RE; MP 10_0159 MOD 1, ROYAL FAR WEST MANLY CONCEPT PLAN MODIFICATION

OBJECTION TO THE PROPOSAL

Response to Amendments to RFW Proposal Dec 2021
 Additional impact (over and above Part 3a approval) in regard shadowing and amenity to 25-29 Victoria Parade
 23 Feb 2022

01 SITE PLAN
 1:250 @ A1
 1:500 @ A3

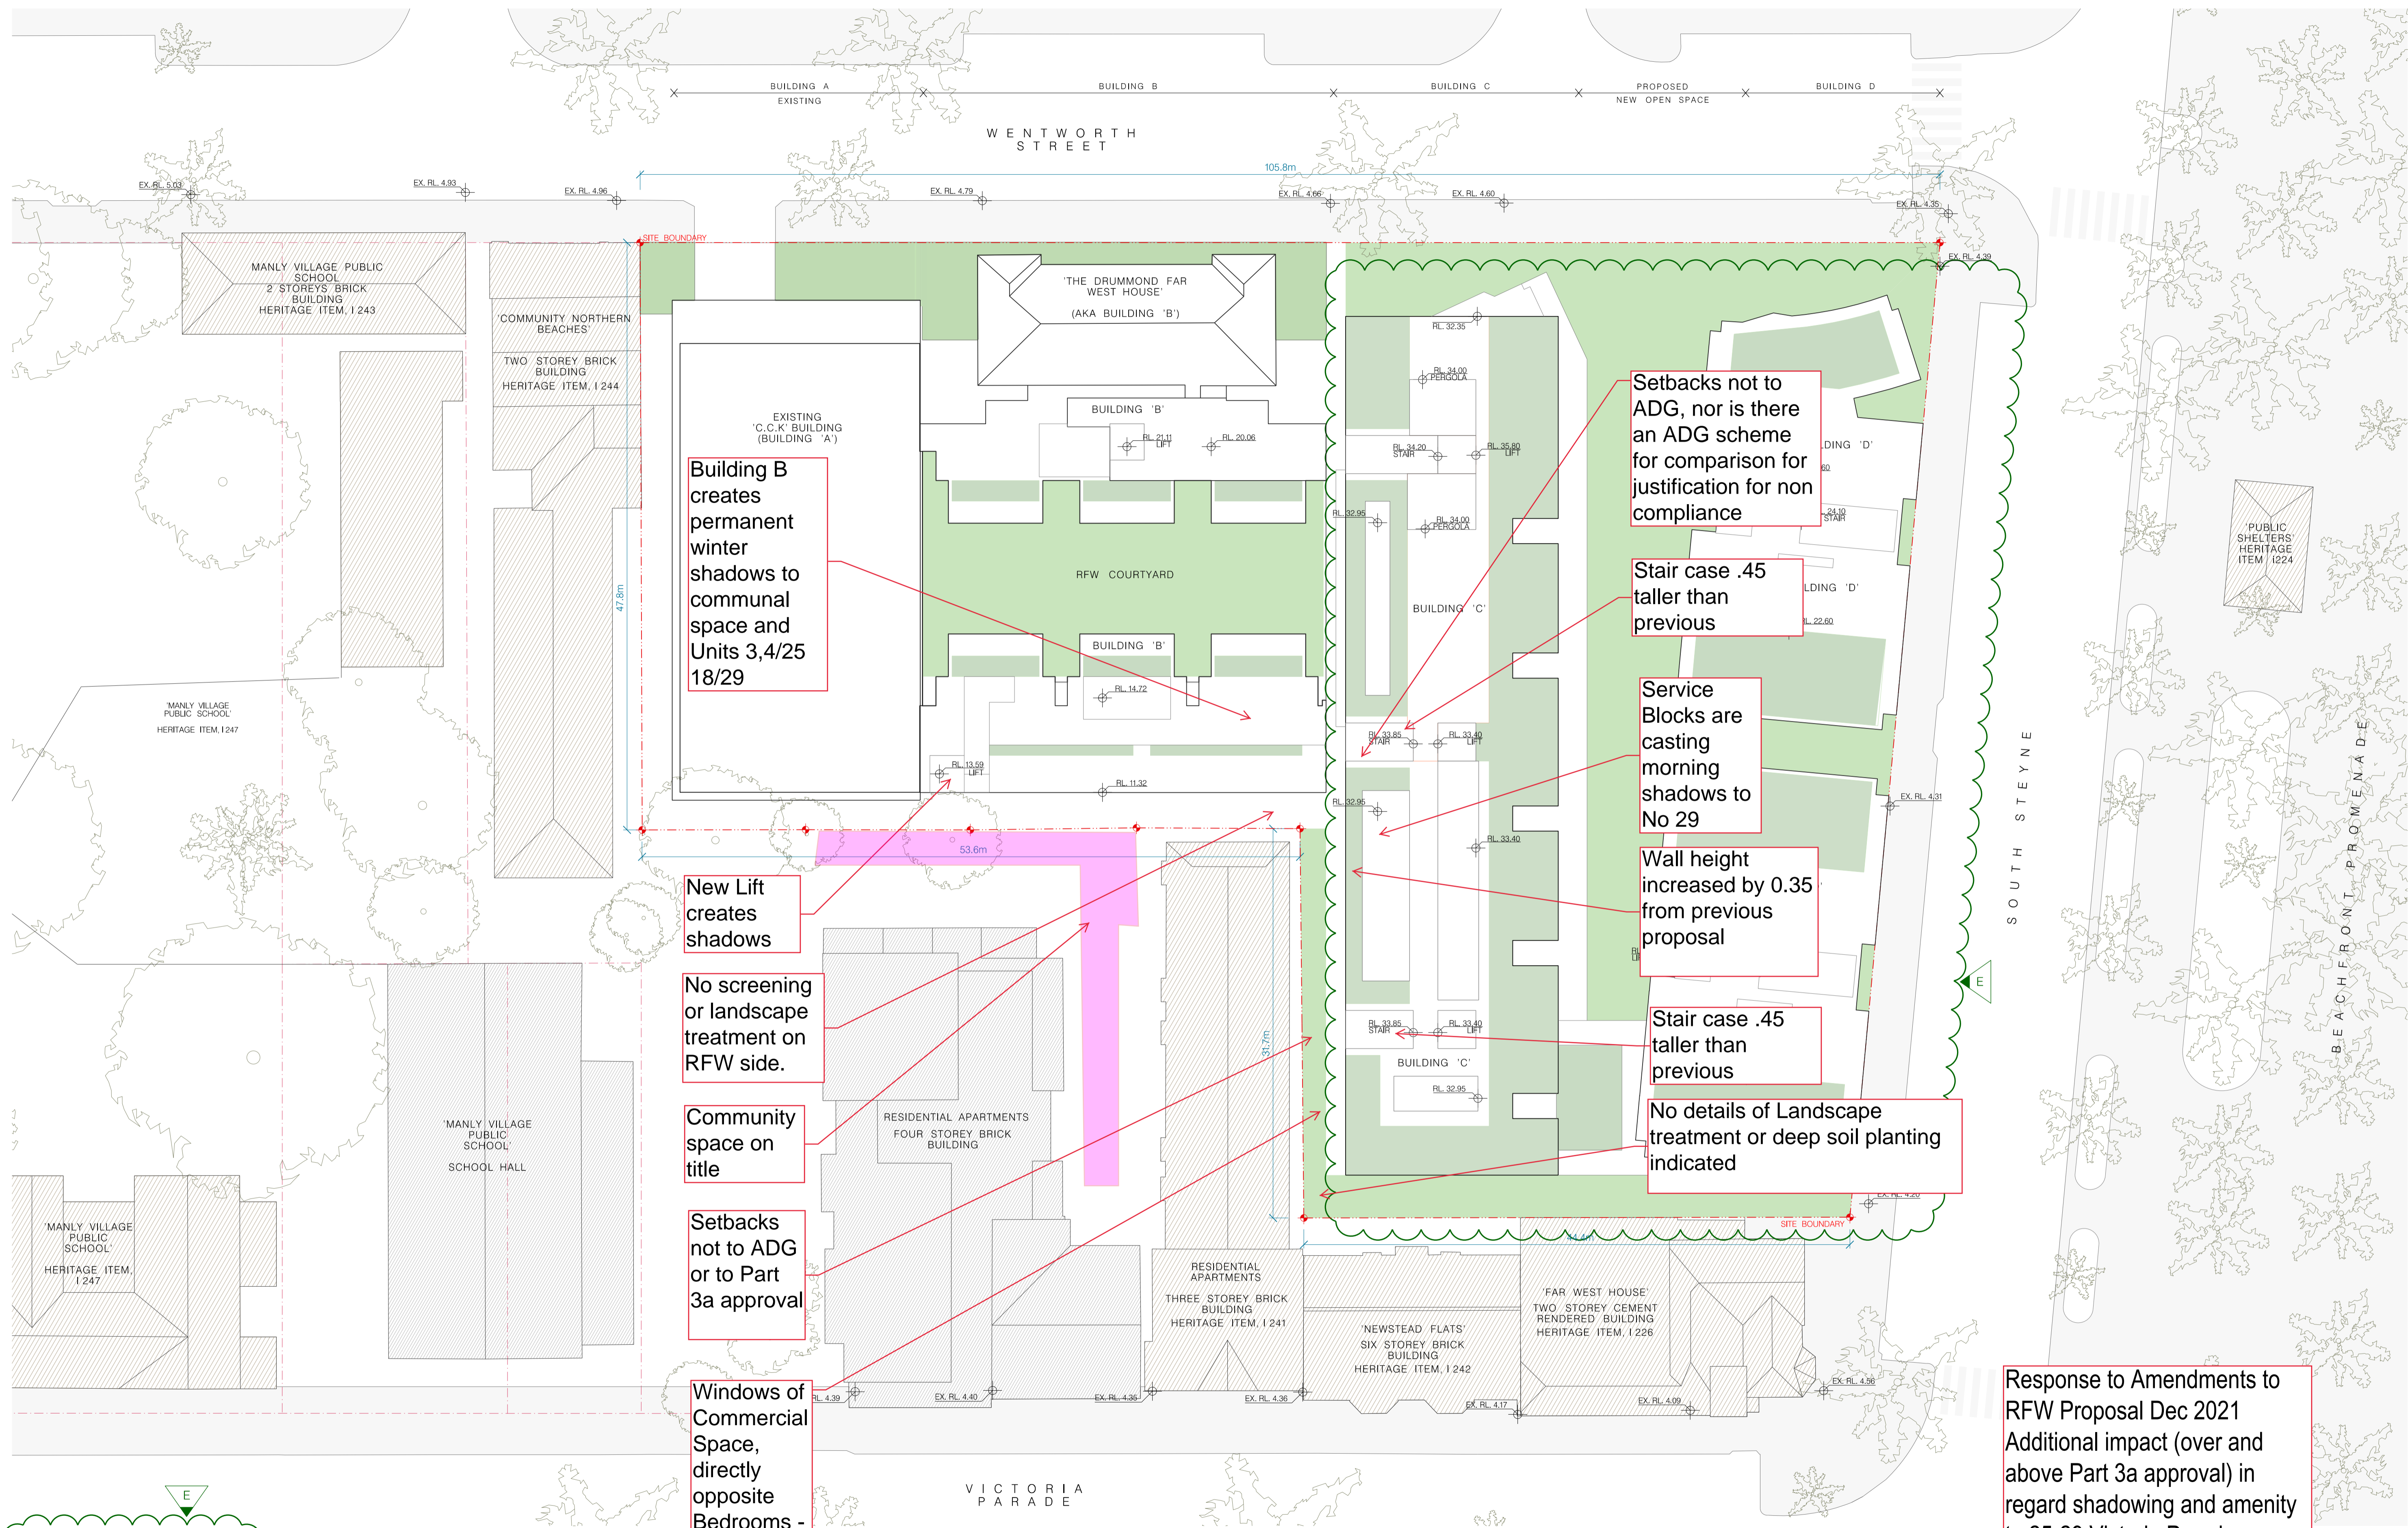
Building B creates permanent winter shadows to communal space and Units 3,4/25 18/29

Setbacks not to ADG, nor is there an ADG scheme for justification for non compliance

Stair case .45 taller than previous

Service Blocks are casting morning shadows to No 29

Wall height increased by 0.35 from previous proposal

Stair case .45 taller than previous

No details of Landscape treatment or deep soil planting indicated

New Lift creates shadows

No screening or landscape treatment on RFW side.

Community space on title

Setbacks not to ADG or to Part 3a approval

Windows of Commercial Space, directly opposite Bedrooms - potential Privacy issues
